SEMI-CONDUCTOR LABORATORY  
S.A.SNAGAR, PUNJAB.

Record of clarifications provided in response to the queries raised by vendors during the Pre-bid conference held at SCL on May 22, 2009 against SCL's Public Tender Notice ref. no. P&S/TSSG/2009/11 execution of a project comprising supply, installation, testing and commissioning of Centrifugal Water Chilling Machines, Cooling Tower etc.

**AC PLANT LAYOUT**  
(Tentative- Not to scale)

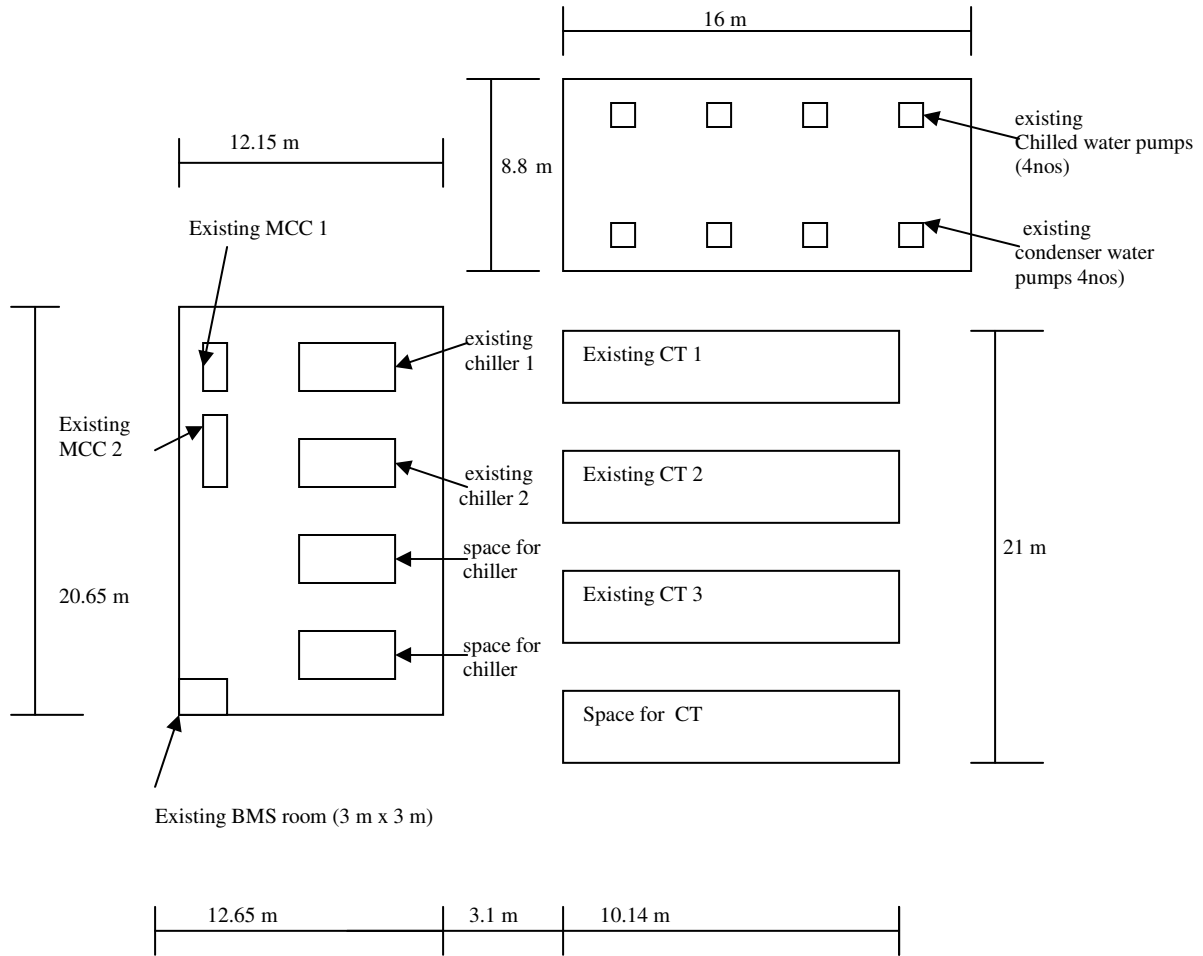
5. In Quote format under PART-C of the Tender Document, quantity of cables, earthing etc. has been indicated as 'Lot' and exact quantity of these items may be specified.

1. It was decided that the Plant Layout drawing of SCL's AC plant shall be sent to the participant vendors immediately and the same shall also be placed on SCL's website.
2. The prospective bidders must take the responses/clarifications as recorded herein into account while submitting the proposal to SCL.

Vendors to work out the quantity of these items based on plant layout drawing to be provided by SCL and quote their rates accordingly as 'Lot'.
